LAND USE APPLICATION SUMMARY

Property Location: 915 West Broadway
Project Name: Brix Grocery and Deli
Prepared By: Aaron Hanauer, Senior City Planner, (612) 673-2494
Applicant: Nadar H Abu-Ammo
Project Contact: George S. Barr
Request: To allow for the construction of a mixed-use building with grocery store and three residential units.

1 SITE PLAN & PLANTING SCHEDULE
 SCALE: 1/8" = 1'-0"
 915 West Broadway

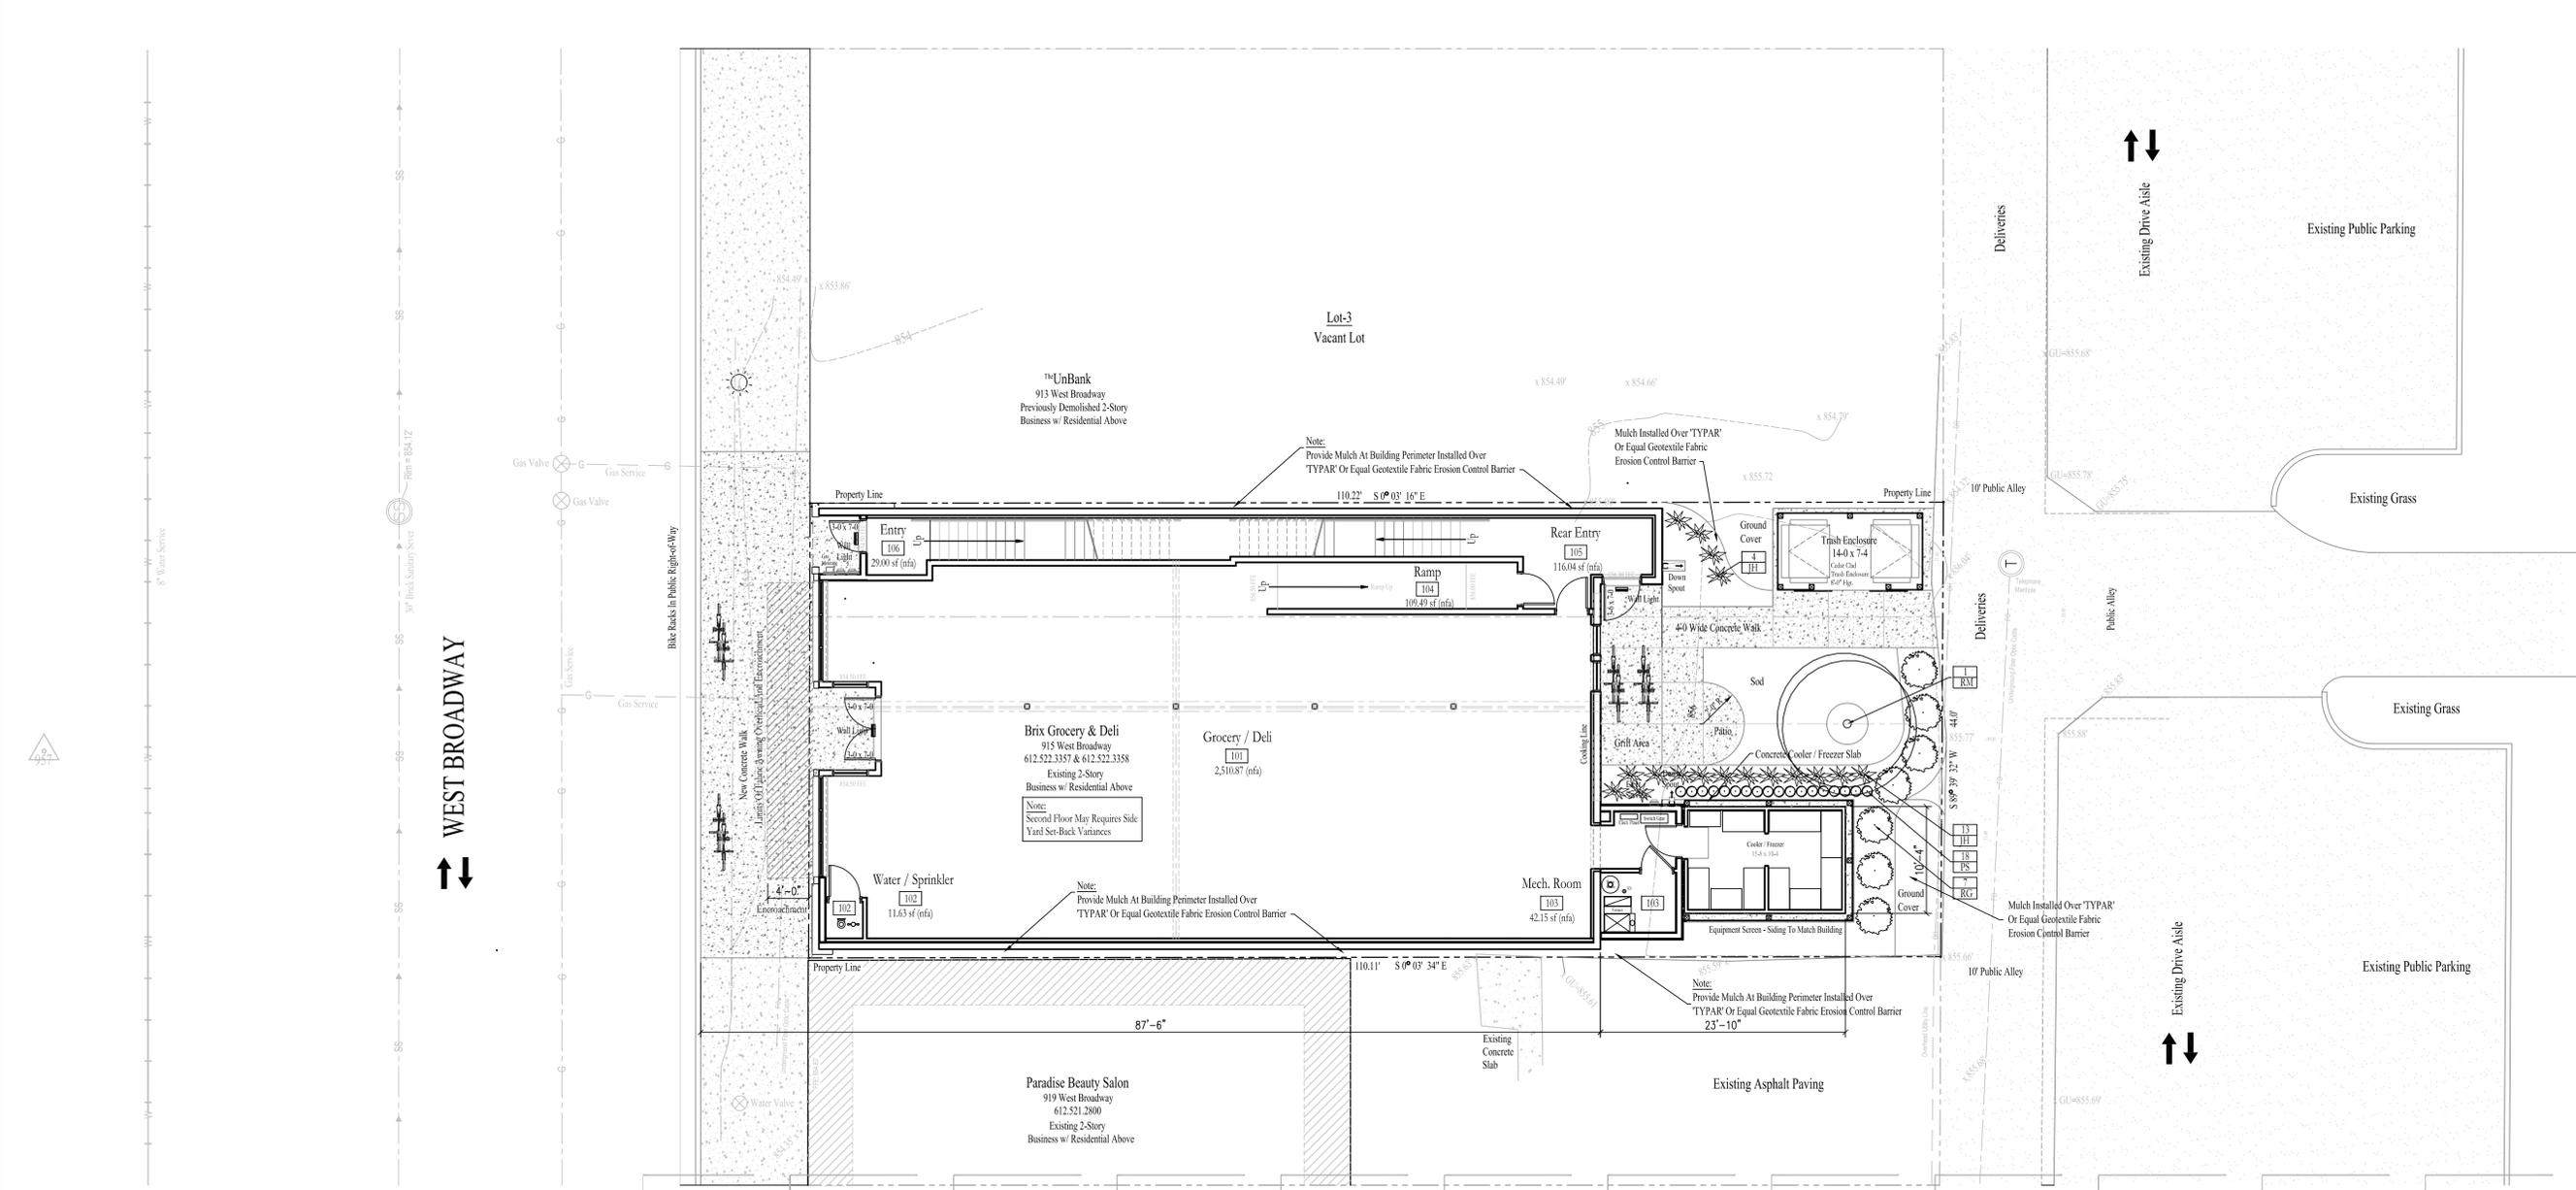
- The proposed site plan minimizes the use of impervious surfaces. The applicant is proposing to exceed the minimum percentage of onsite landscaping required (see Table 3).

- As a condition of approval, the required landscaped area shall be covered with turf grass, native grasses, perennial flowering plants, vines, shrubs and other trees. In addition, the plant materials, and installation and maintenance of the plant materials, shall comply with sections 530.200 and 530.210 of the zoning code.

- The applicant is proposing an 8-foot tall, cedar clad trash enclosure at the rear of the site. The trash enclosure is proposed to be one foot from the side property line and two feet from the rear property line. This location is permissible given that the neighboring property to the east does not retain rights to a residential use and the subject property is separated from a residentially zoned property to the south by a public alley. As a condition of approval, plans shall be submitted prior to building permit issuance showing the details of the trash enclosure in full compliance with Section 535.80-Screening of refuse and recycling storage containers.

4. Plans shall be submitted prior to building permit issuance showing the details of the trash enclosure in full compliance with Section 535.80-Screening of refuse and recycling storage containers.

915 WEST BROADWAY AVENUE - EAST EXTERIOR ELEVATION
CONCEPTUAL TINTED CONCRETE MASONRY EXTERIOR
Scale: 3/16 " = 1'-0"

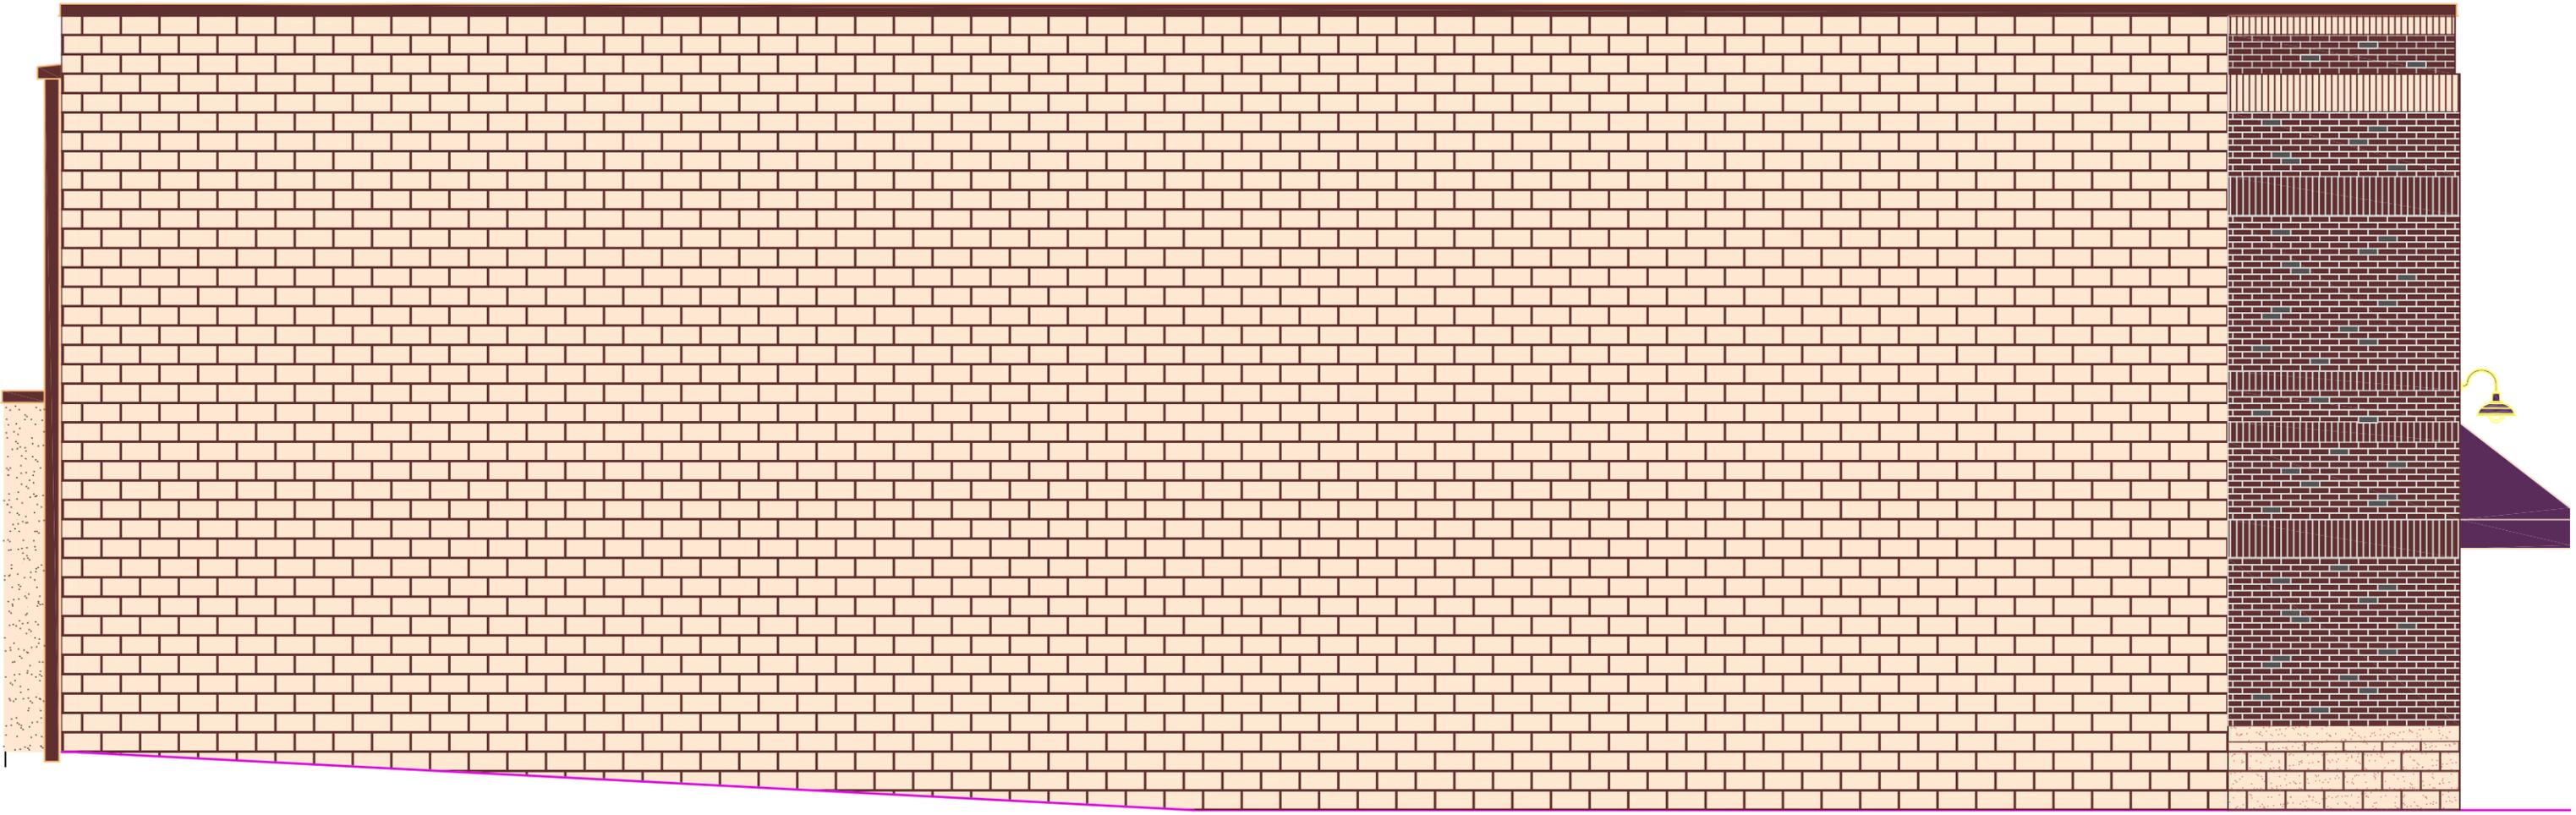
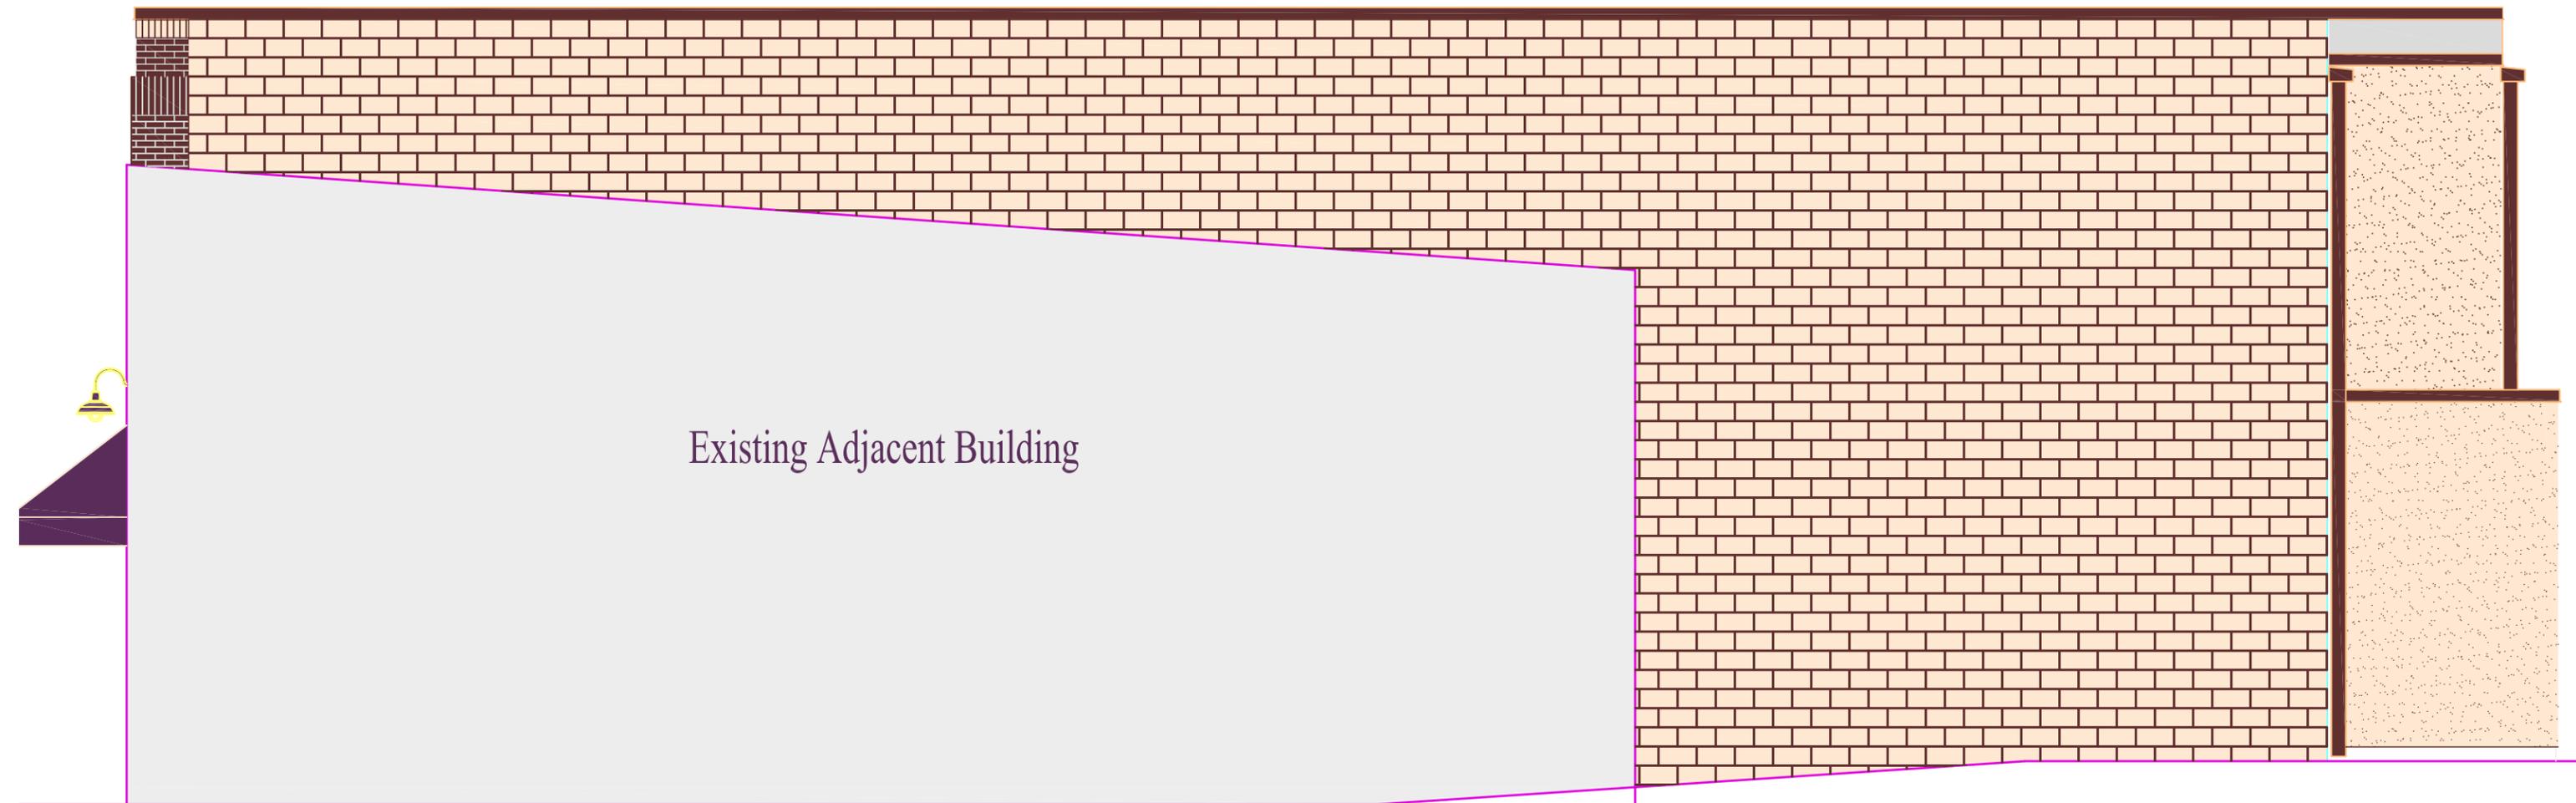
- The building walls include architectural detail that will create visual interest including a face brick soldier course cornice, window sills and lintels, large storefront windows, and a fabric awning,
- The east and west elevations are proposed to have blank, uninterrupted walls exceeding 25 feet in length. Alternative compliance is required.

- **Blank walls:** As required by Section 530.120-Building design, blank, uninterrupted walls that do not include windows, entries, recesses or projections, or other architectural elements, shall not exceed twenty-five (25) feet in length. The purpose of this requirement is to encourage building walls to have architectural detail and windows in order to create visual interest and to increase the security of adjacent outdoor spaces by maximizing natural surveillance and visibility. The applicant is proposing to have blank walls most of the east and west elevations. Alternative compliance is required. CPED finds that the strict adherence to the requirements is impractical because of site location or conditions. The applicant is proposing to rebuild the commercial, mixed-use building in a traditional urban fashion and similar to what was previously on this site. This includes building from side lot line to side lot line in order to have continuous building wall frontage along West Broadway. Given that the proposed building is within a foot of the side property lines, window openings are not allowed by building code. In addition, the side elevations will have significantly less visibility given that they will be masked by an existing building to the west and it is anticipated that future development plans for the parcels to the east will also build near the shared property line with the subject property.

- **Percentage of exterior building materials allowed:** Plain face concrete block is considered a durable material; however, the *Guide to Exterior Building Walls and Materials* does not provide an allowed percentage for this material on elevations. As outlined in Chapter 530, the use of plain face concrete block as an exterior material shall be prohibited where fronting along a public street, public sidewalk, public pathway, or adjacent to a residence or office residence district. The purpose of the exterior building material allowances and limiting plain face concrete block requirements is to have new buildings and additions constructed with high quality building materials that are durable, while also positively contributing to the built environment, and providing architectural details that is visually appealing. The applicant is proposing to have nearly 100 percent plain face concrete block on the east and west side elevations. The proposed concrete block would be tinted a color to complement the brick on the front elevation. Alternative compliance is required. CPED finds that the strict adherence to the requirements is impractical because of site location or conditions. The applicant is proposing to rebuild the commercial, mixed-use building in a traditional urban fashion and close to what was previously on this site. This includes building within a foot of the east and west side elevations. Given that the proposed building is within a foot of the side property lines and the adjacent building is at the shared side property line, the concrete block will have minimal visibility from West Broadway. Also, it is anticipated that the eastern elevation will not be visible from West Broadway once new construction is complete at 905-913 West
